# ADDENDUM 1

PROJECT NAME: **MARTIN LUTHER KING PARK**

DATE: 09/21/2016

PROJECT NO.: **40-00374**

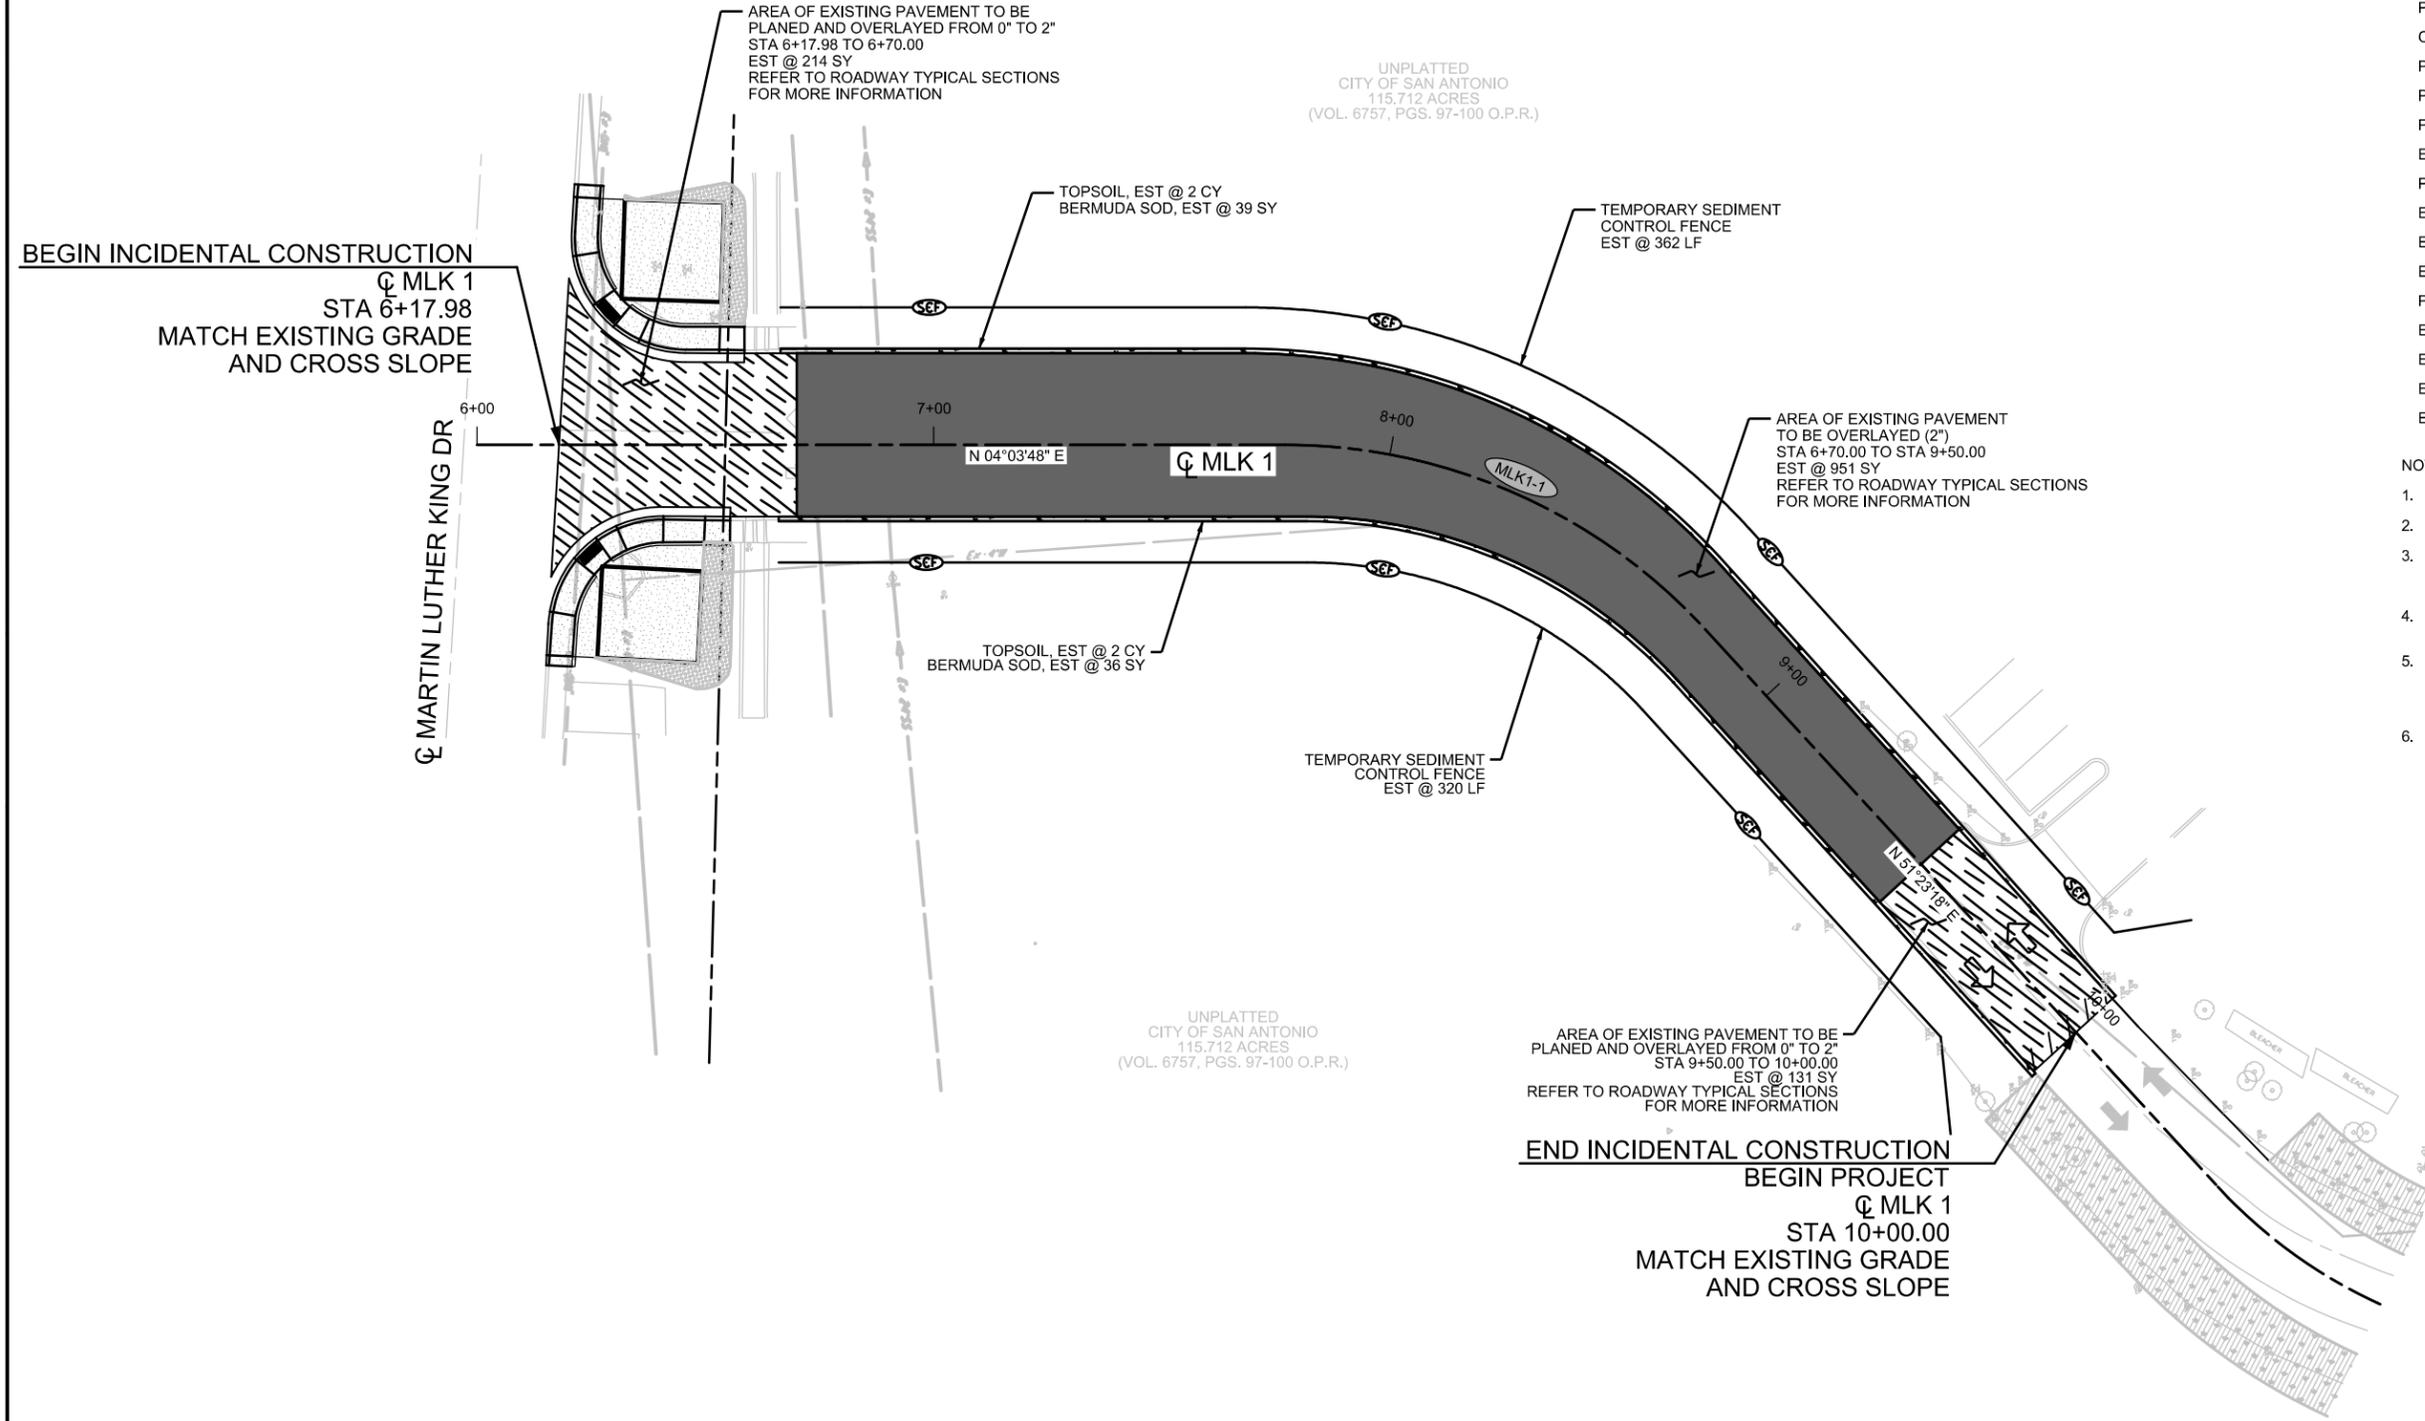
- iii. Revised plan note No. 6
- r. Sheet 52A “ADDITIVE ALTERNATIVE NO. 2 – MLK 1 STA 6+17.98 TO 10+00.00”
  - i. Added Sheet 52A “ADDITIVE ALTERNATIVE NO. 2 – MLK 1 STA 6+17.98 TO 10+00.00”

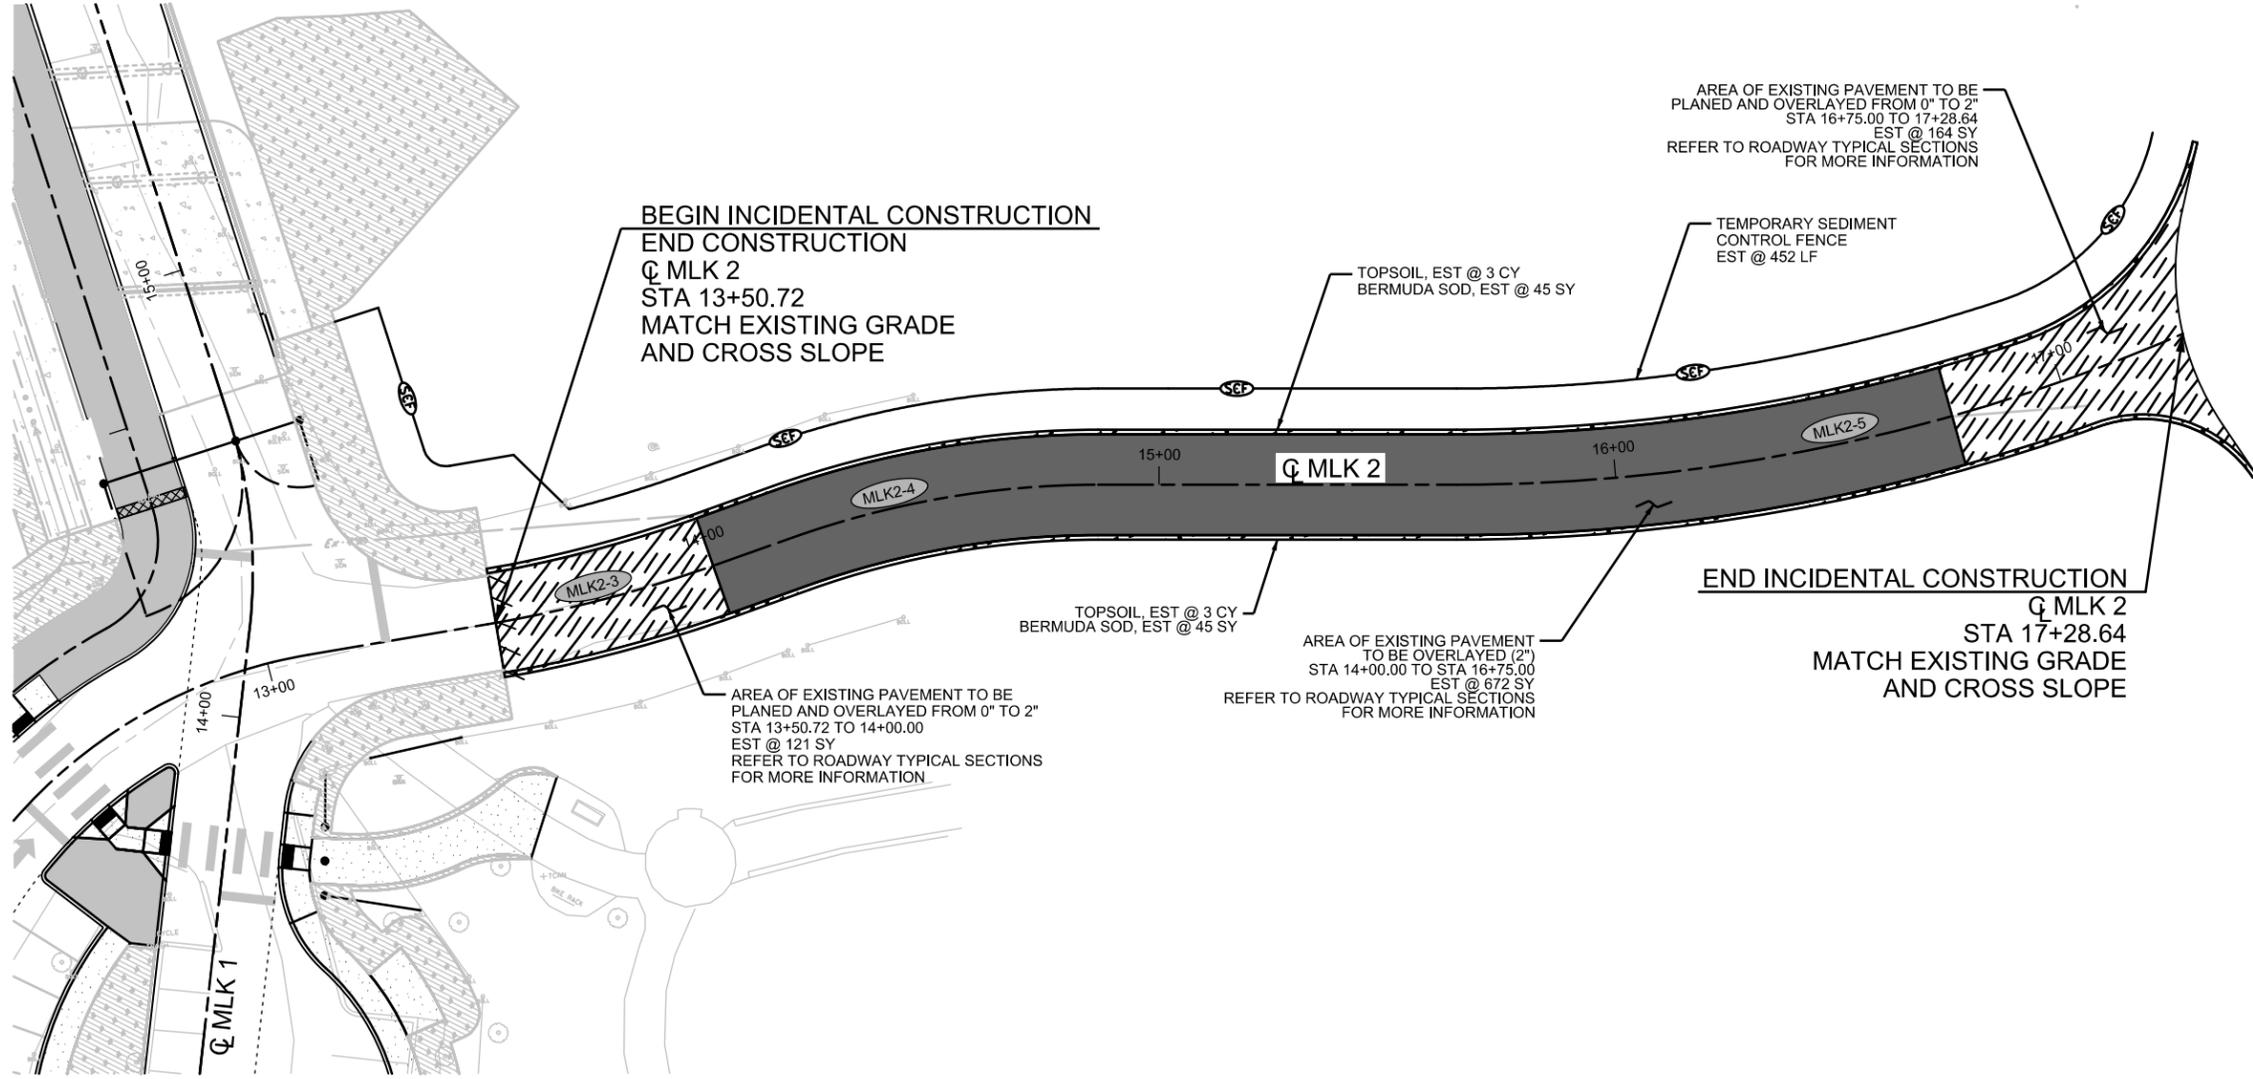
- s. Sheet 52B “ADDITIVE ALTERNATIVE NO. 3 – MLK 2 STA 13+50.72 TO 17+28.64”
  - i. Added Sheet 52B “ADDITIVE ALTERNATIVE NO. 3 – MLK 1 STA 13+50.72 TO 17+28.64”

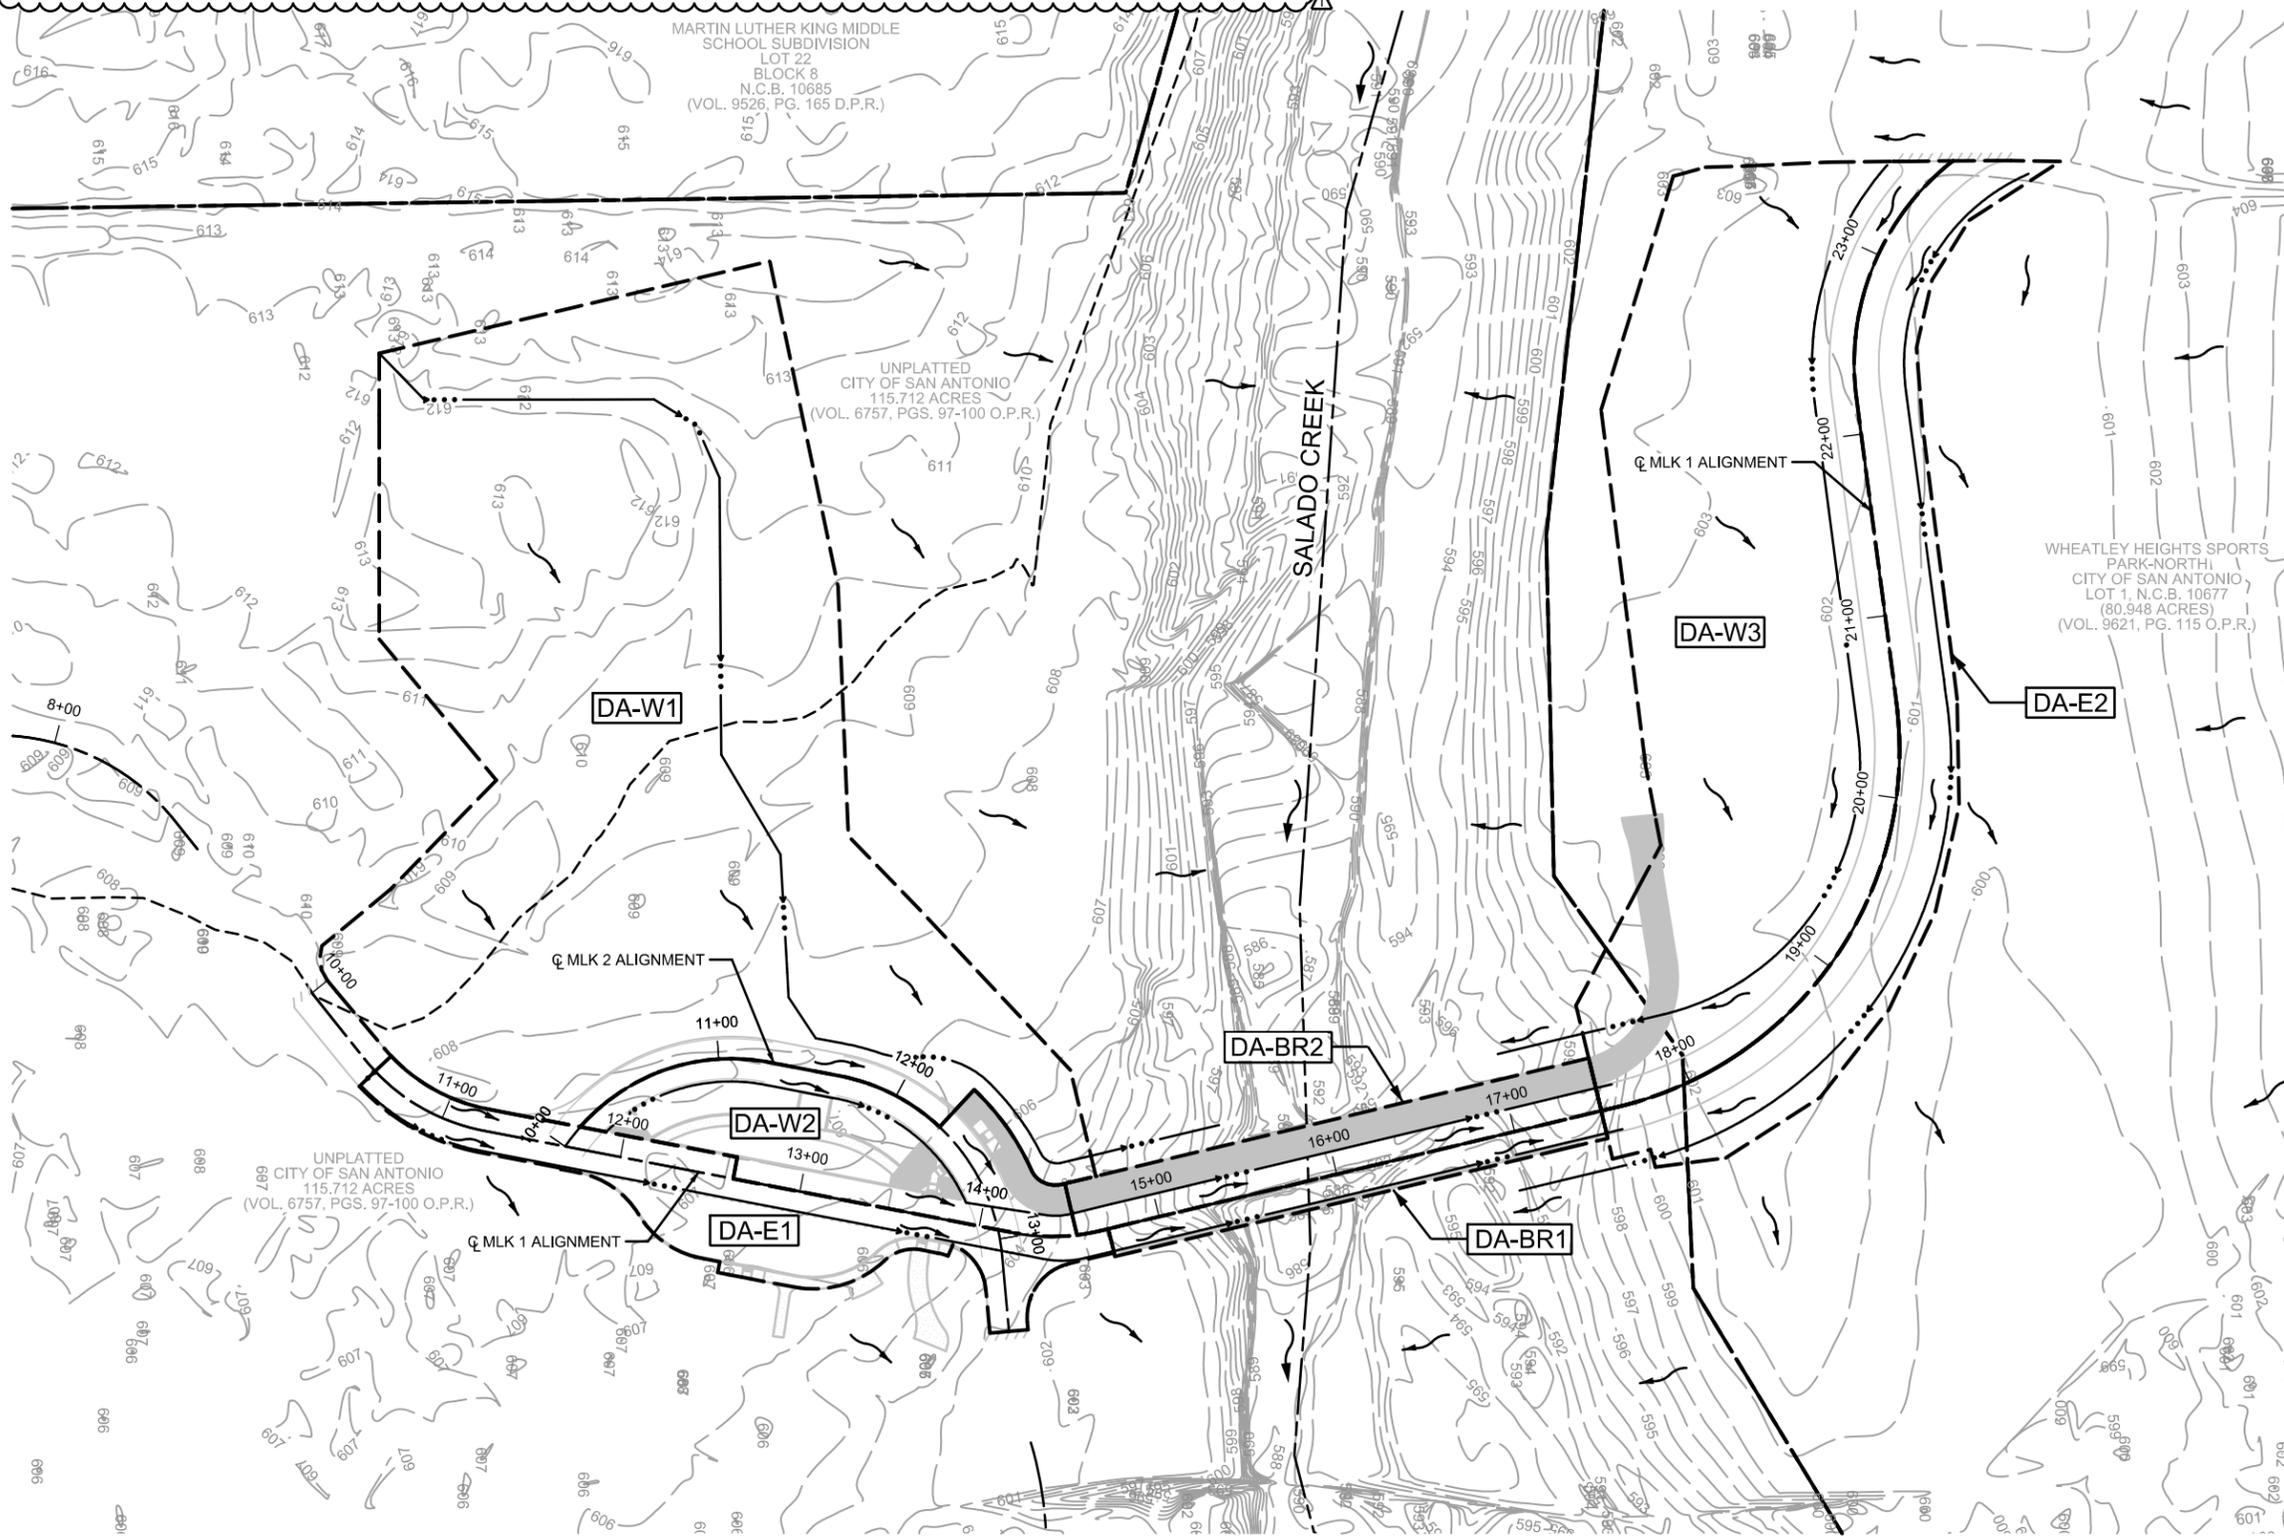
- t. Sheet 67 “DRAINAGE AREA MAP”
  - i. Added 25-YR and 100-YR rainfall intensities

- ii. Updated Flow Q for 5-YR, 25-YR AND 100-YR.
  - u. Sheet 68 “HYDROLOGIC COMPUTATIONS (INTERNAL DRAINAGE)”
    - i. Revised calculations to correspond with updates made to “DRAINAGE AREA MAP” rainfall intensities and flows
